Response to Comments Proposed Closure Plan for the PUREX Tanks TK-P4 and TK-40

For the **Nuclear Waste Program**

Washington State Department of Ecology

June 2021, Publication 21-05-013

Figure 2: Tanks TK-P4 and TK-40, located in the 203A and 211A storage areas at the PUREX Plant

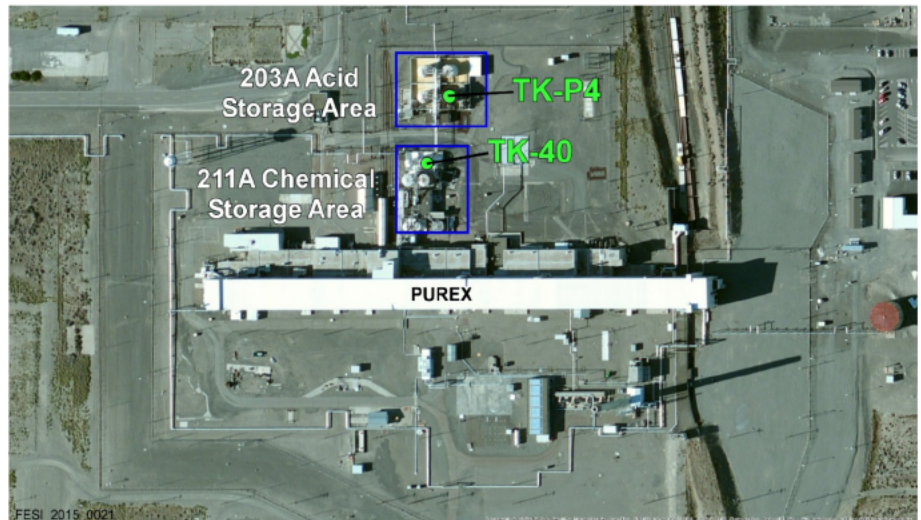
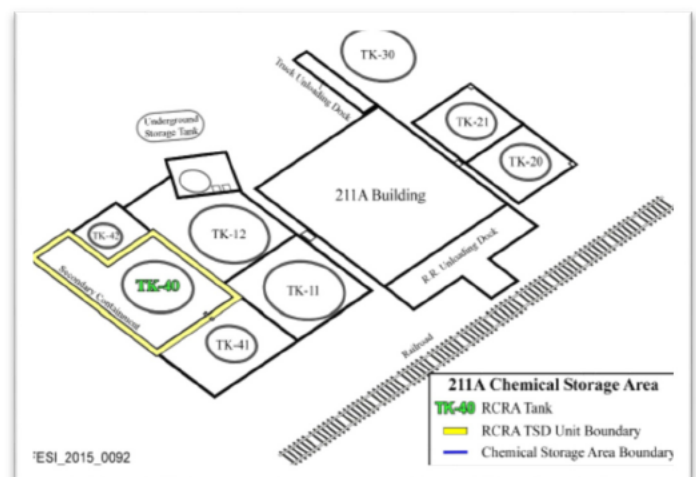
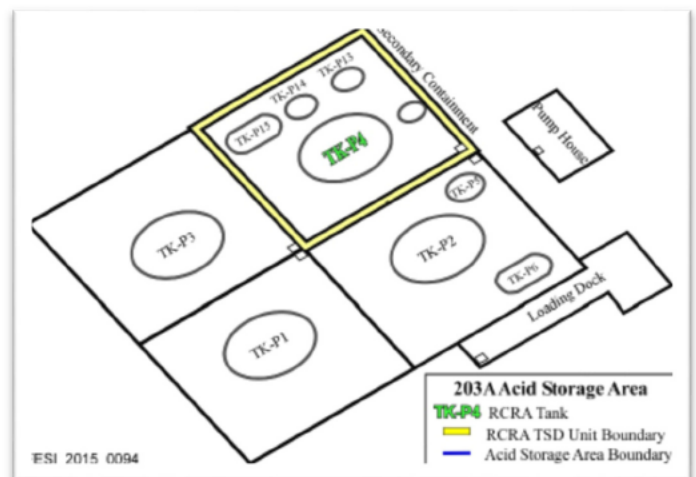
Following is my short comment on the changes proposed for the PUREX plant. I found it very hard to determine where tanks TK-P4 and TK-40 are situated using Figures 2 and 3. The drawings shown do not seem to match the photograph. The boxes in the two drawings of Figure 3 don't seem to appear on the photograph in figure 2. I find this very disturbing. It's a precursor to questions about truth in the proposal.

The drawings of Tanks TK-P4 and TK-40 have been updated to better match the photographs and to clearly depict the tank locations. These drawings are in Section 1.2, Figure 2.
